October 11, 2024

**RE: 80 Willow Road (PLN2023-00049) – Completeness Review – Incomplete**

*Request for Architectural Control, Tentative Map, Below Market Rate Housing Agreement, and Environmental Review to demolish an existing commercial office building and construct three new mixed-use buildings ranging in height from approximately 301 feet to 461 feet tall, including 665 residential units of which 133 units (20 percent) would be designated below market rate housing affordable at the low-income level, approximately 336,000 square feet of office, approximately 29,000 square feet of retail space, and a hotel with 130 rooms. The project also includes a use permit request for a new private school use.*

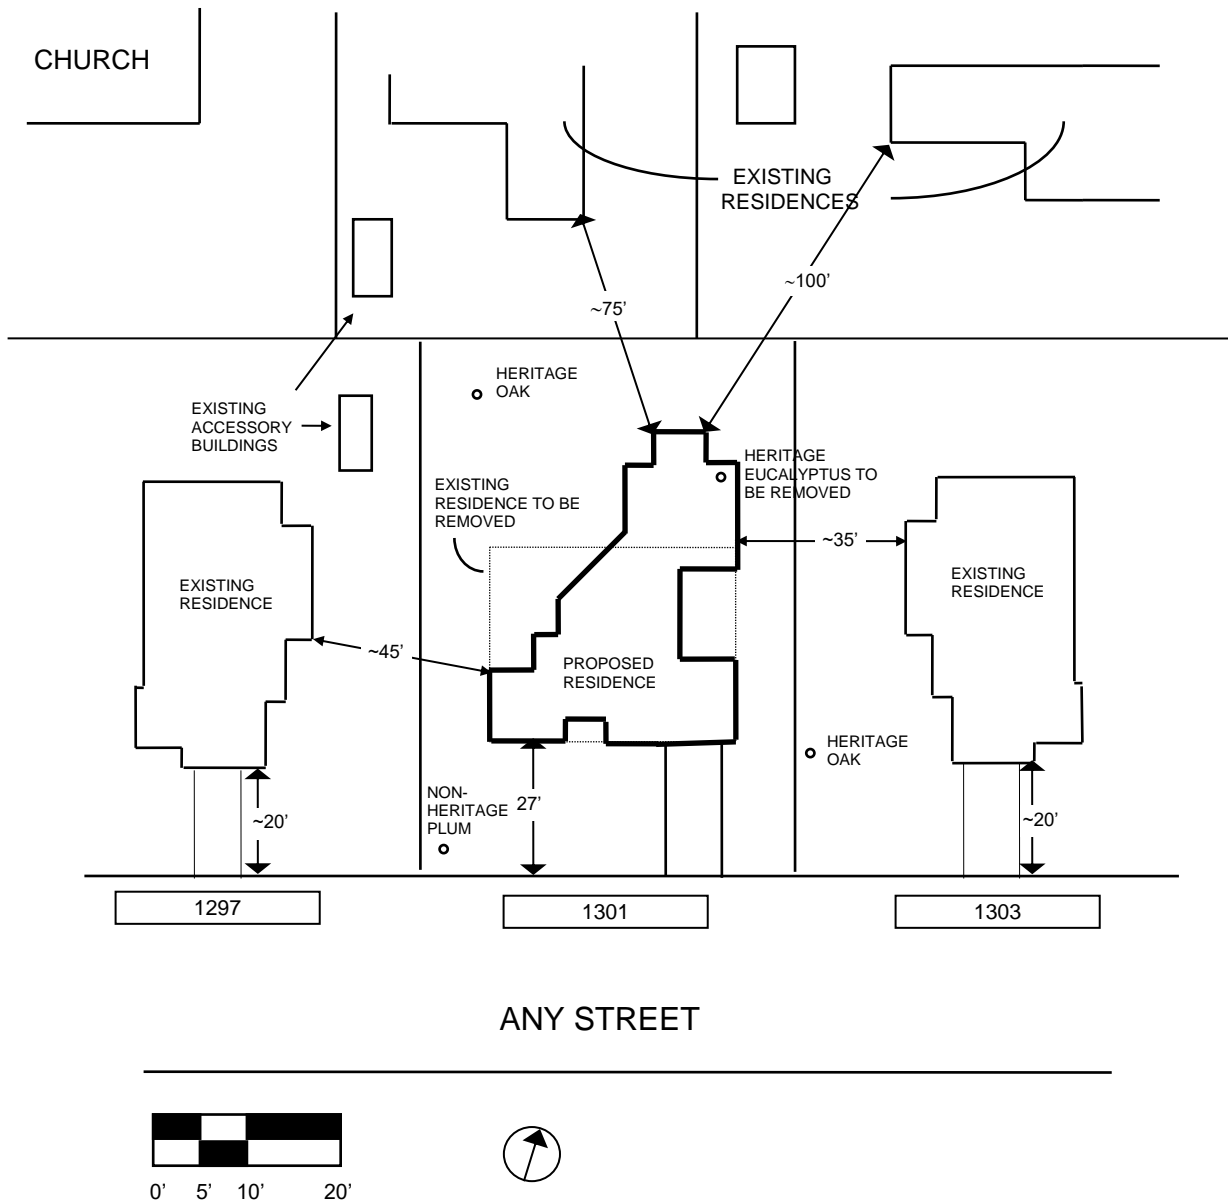
*Incomplete – The area plan does not extend sufficiently to show the area across streets and driveways on facing parcels as illustrated in the Example of Area Plan diagram below.*

*Correction – Revise area plan to sufficiently show the area across streets and driveways on facing parcels as illustrated in the Example of Area Plan diagram below*

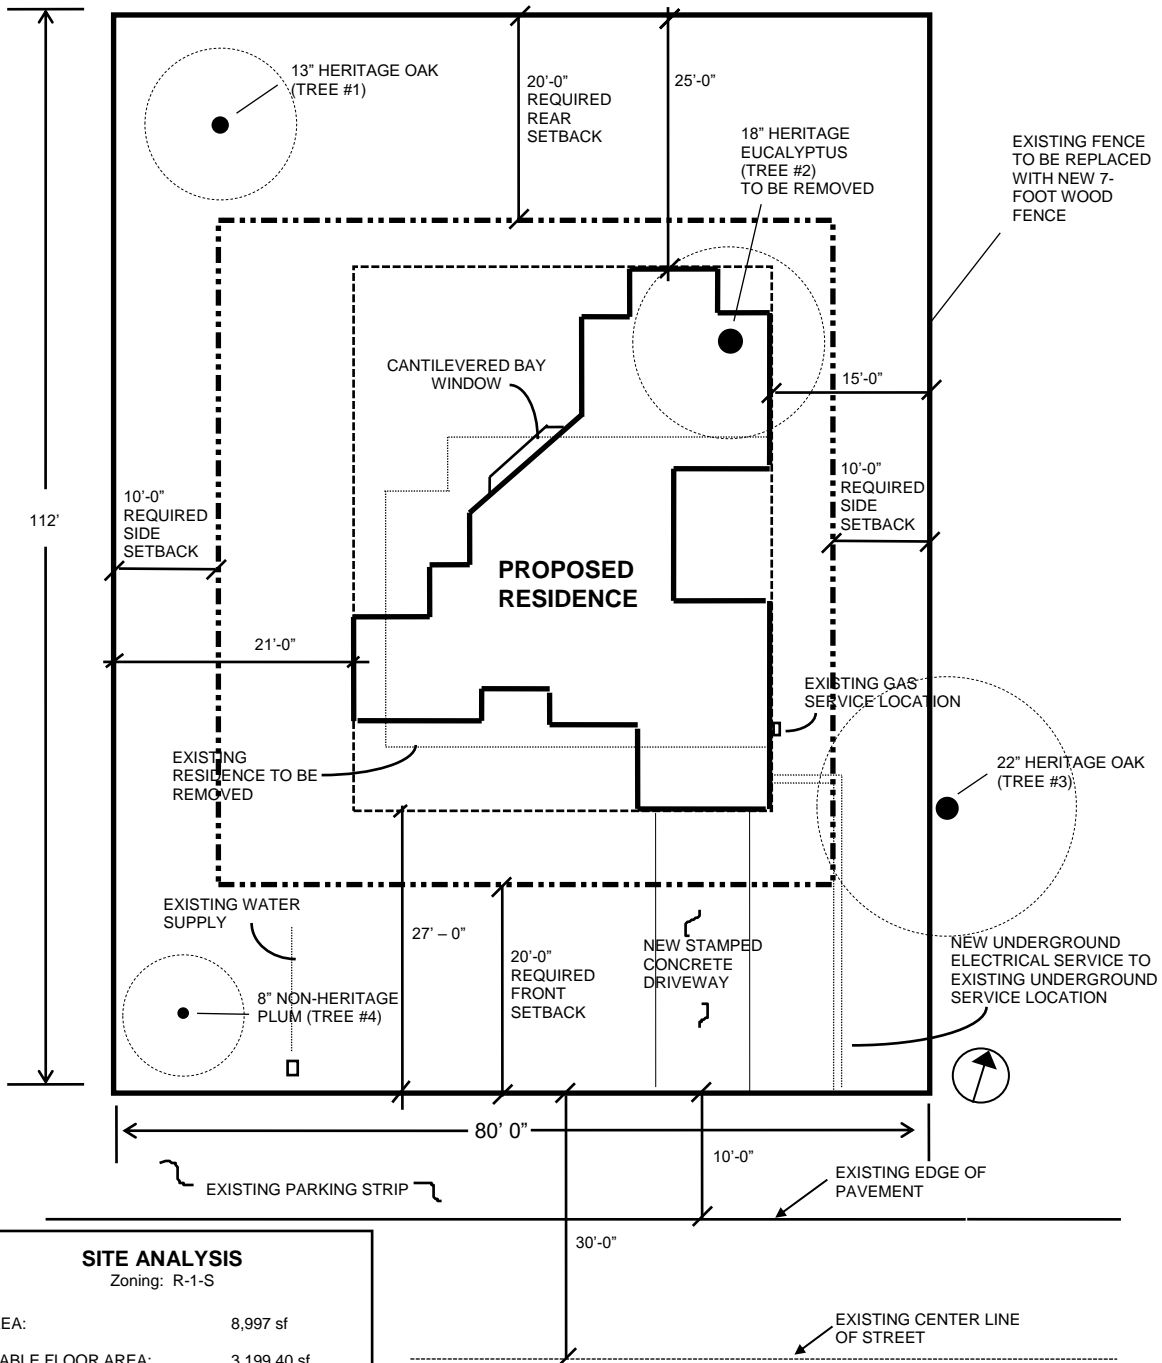
***Incomplete – The site plan does not identify the following site analysis information (see sub-bullets o-s).***

- ***Net sq. ft. exclusive of access easements***
- ***Existing sq. ft. of each floor of existing building(s)***
- ***Percentage of paved and landscaped areas***
- ***Total number of covered and uncovered parking spaces (total spaces are provided and broken down by building location, EV, accessible, etc.) but it is not noted whether***

they are covered or uncovered. (There are a few surface spaces shown on the site plan.)

***Correction – Although the required site analysis information is not shown on the site plan, staff accepts the information being shown on sheet A0.02 (Project Information) due to the large volume of information to be provided. Revise sheet A0.02 (Project Information) to identify the following site analysis information (see sub-bullets o-s). Provide information in a table form, as appropriate. Site analysis information missing on Project Information sheet:***

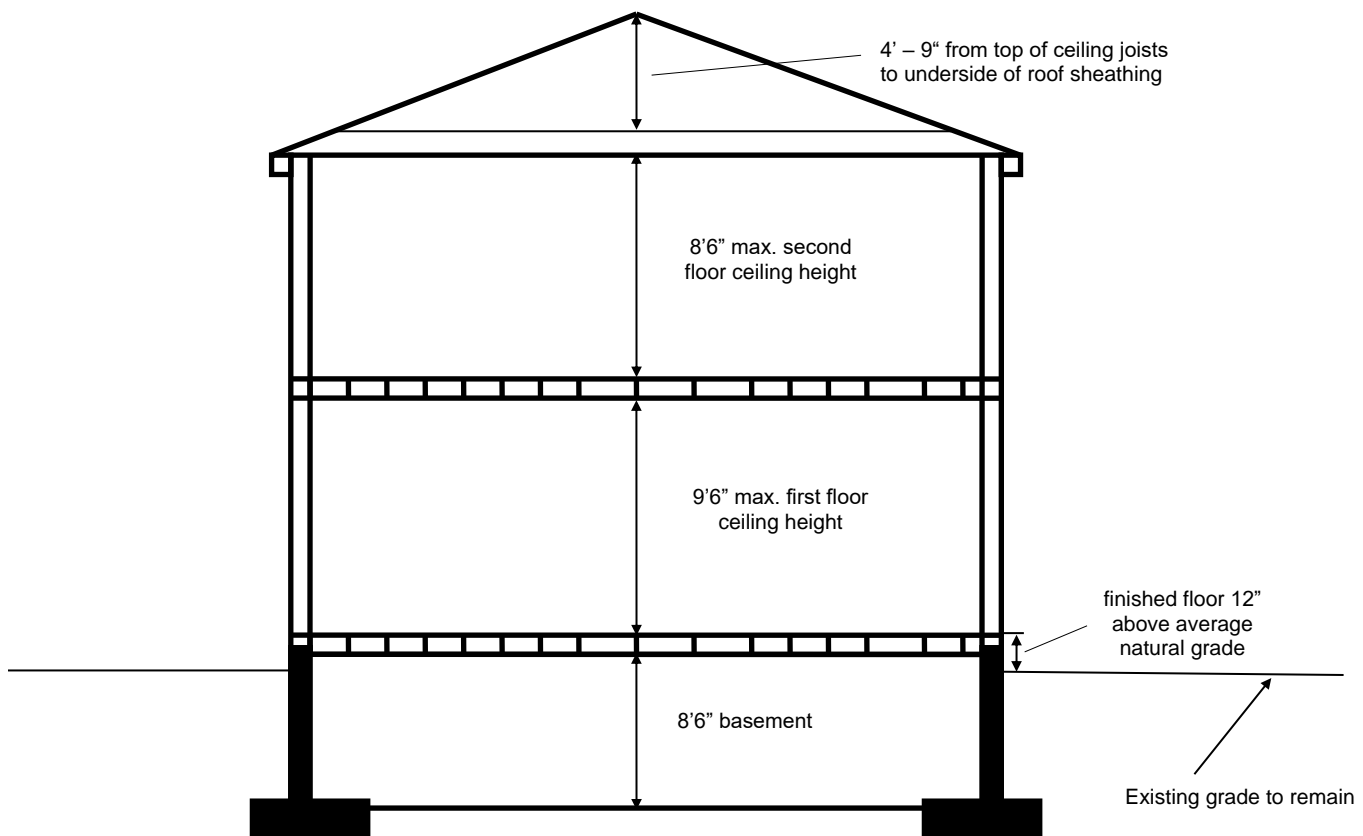
*Incomplete – Sections do not show the existing and proposed grade of the property. No sections of the Montessori school are provided.*

*Correction – Show the existing and proposed grade of the property. Provide sections of the Montessori school. Please be advised that additional cross sections may be needed to determine compliance with City requirements.*
